SERVICE BULLETIN

**CONVENTIONAL AIR CLEANER HOUSING BOOT
DEFORMED**

**GROUP: 0-GENERAL
BULLETIN NO: SB-18-027
DATE: 9-28-2018
REF: HMM-180917-B1**

SUBJECT VEHICLES: 11MY-18MY Conventional Trucks equipped with a J08 engine

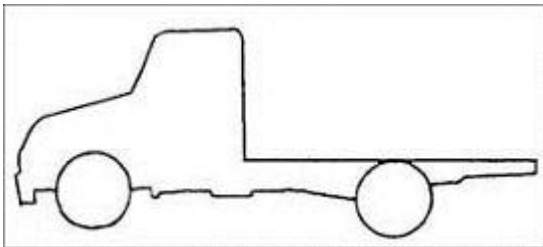
The subject vehicle may experience an appearance concern of the air cleaner housing boot. This deformation does not affect function. The air cleaner housing boot has been changed, removing the ribs on the front side to prevent deformation. This boot can be replaced separately from the air cleaner housing if replacement is desired.

Part Number	Part Description	Quantity
17714EV030	Air Cleaner Housing Boot	1
17783EV010	Retainer Pins	As Needed (4 maximum)
